Ref. No. AAG-76-4 November 22, 1976

LEGAL METROLOGY AND LABORATORY SERVICES BRANCH

RE: CANADIAN METER COMPANY BVI-CI, MODEL 100

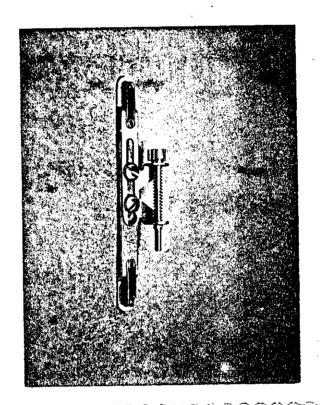
The manufacturer has introduced a change in the 'zero' adjustment provision for this device. The adjustment has been removed from the pressure system take-off arm and relocated to the pressure transfer link.

The new zero adjustment provision incorporates a spring-loaded transfer link intended to eliminate backlash and enhance repeatability of fine zero adjustments. This change has been approved.

All new BVI-CIs Model 100 with serial No. VCI-1700 and higher will have this change incorporated. However, permission has also been granted to incorporate the new zero adjustment provision on any BVI-CI Model 100 of an earlier production, when a need arises to replace the pressure tube assembly, due to damage or other reasons. Because the new replacement pressure tube assemblies will not carry the zero adjustment on their take-off arm, the new spring-loaded transfer link, Part No. 50925G005, must also be incorporated, otherwise the instrument will lack any zero adjustment provision.

An illustration in this Circular shows the spring-loaded transfer link with the zero adjustment.
